Subject: Response to FDEP Letter Dated February 12, 2009

#### **RESPONSES TO FDEP COMMENTS DATED FEBRUARY 12, 2009**

Subject: Sinkhole Potential

**FIGURE-1**  
**SINKHOLES LOCATED WITHIN 1 MILE**  
**RADIUS OF WEST PASCO LANDFILL**  
**PASCO COUNTY, FLORIDA**

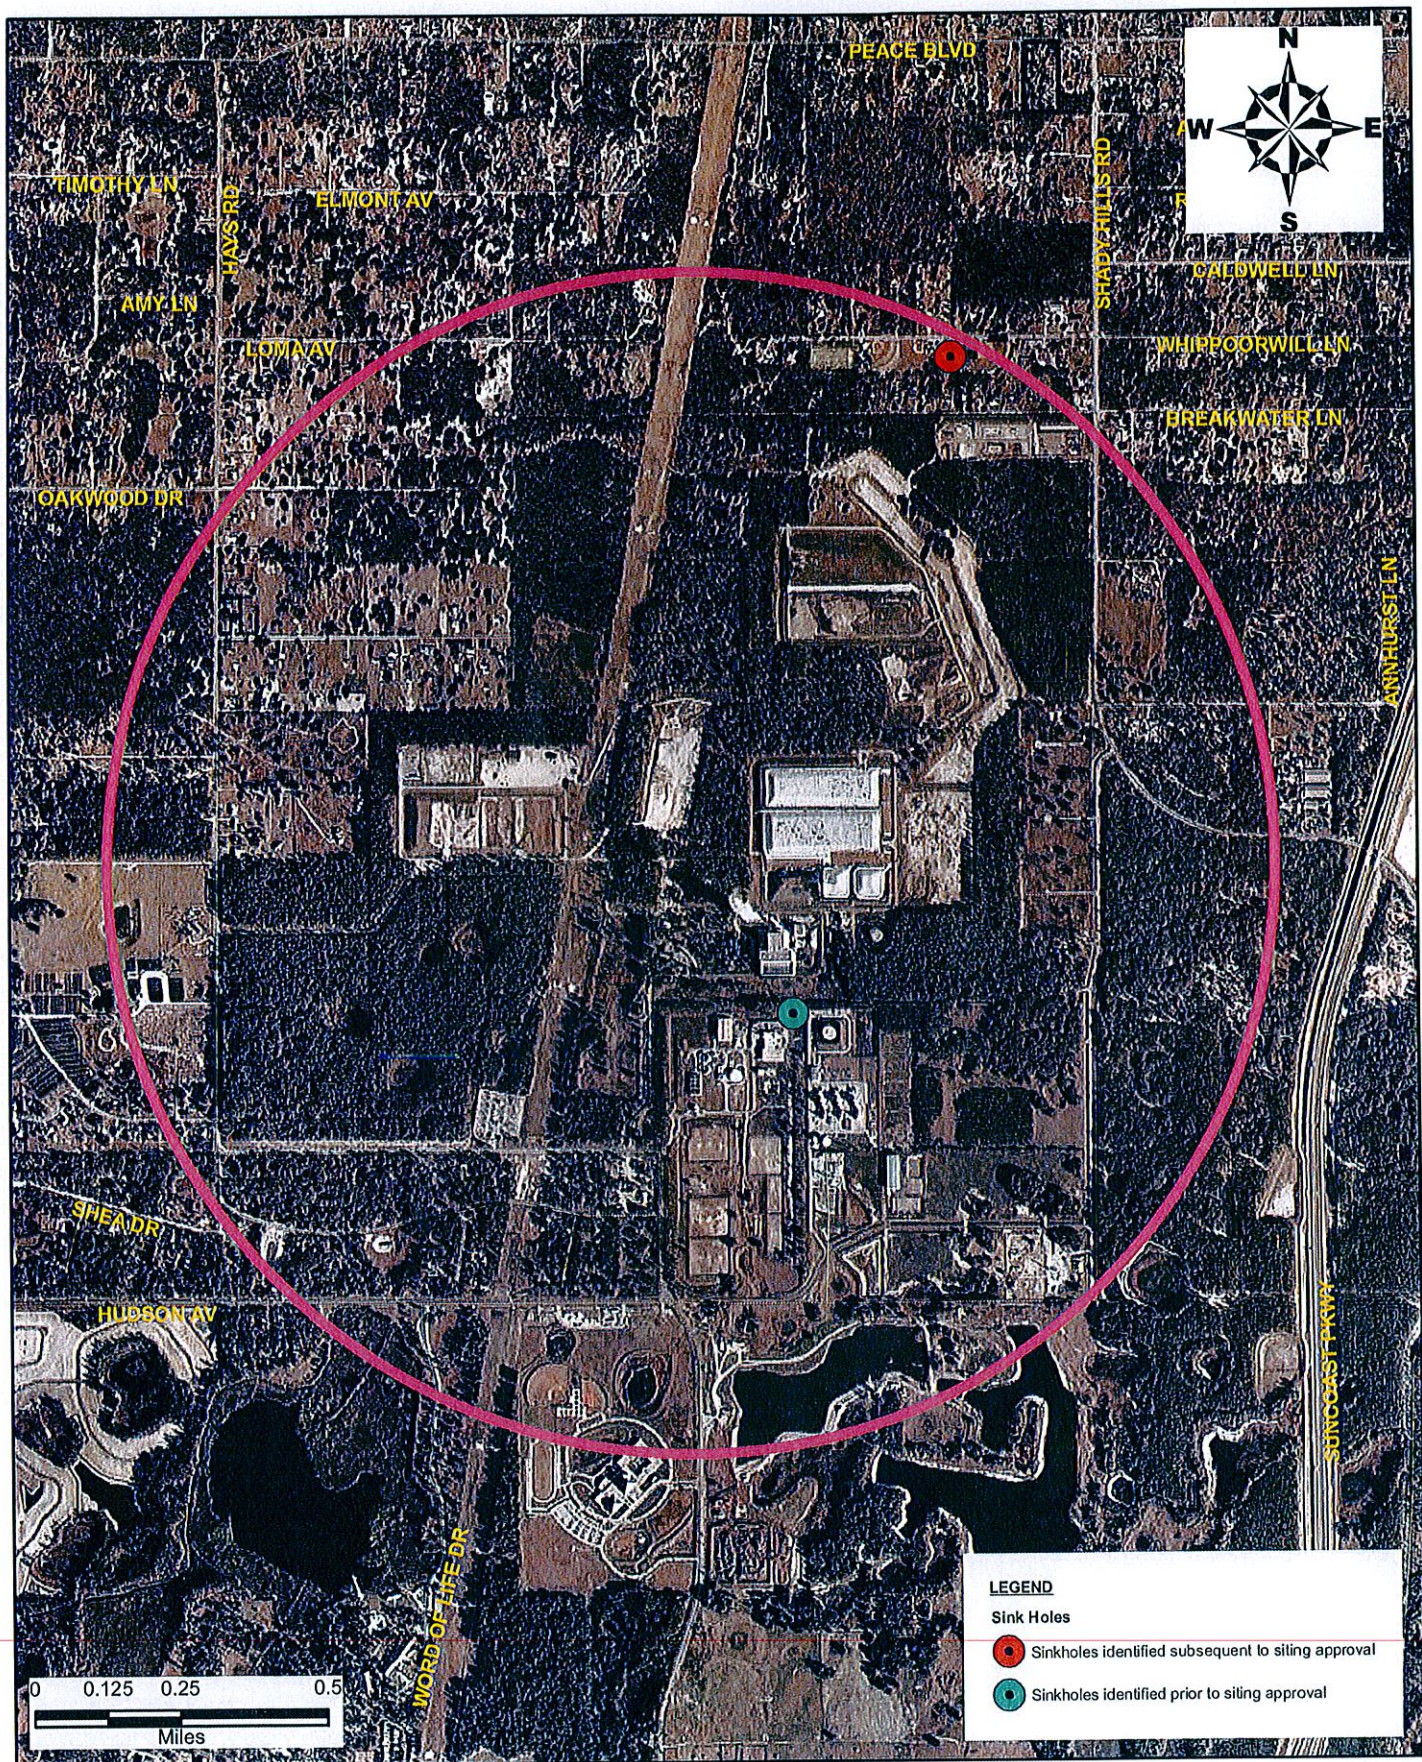
Comment 1.b.3) requests an evaluation of sinkhole occurrences since the 1987 Jammal report.

**Response:** Information in the FDEP sinkhole database indicates that two sinkholes have been identified within one mile of the proposed A-4 Ash Cell. One was identified subsequent to Power Plant Site Certification approval. Additional information is provided as Attachment 1 to this letter.

As a follow-up to our discussion yesterday, please find as Attachment 1 to this letter, **Figure 1** identifying known sinkholes located within a 1 mile radius of the West Pasco Landfill. The data used to prepare this figure was obtained from the Florida Department of Environmental Protection's website. As shown in Figure 1, there is one sinkhole that has been identified subsequent to the Power Plant Siting Board's approval of the site as a Class I landfill. This sinkhole is best characterized as a broad, gently-sloping depression, similar in nature to the sinkholes identified in the original geotechnical investigation that was submitted in support of the County's November 1987 application for Power Plant Site Certification.
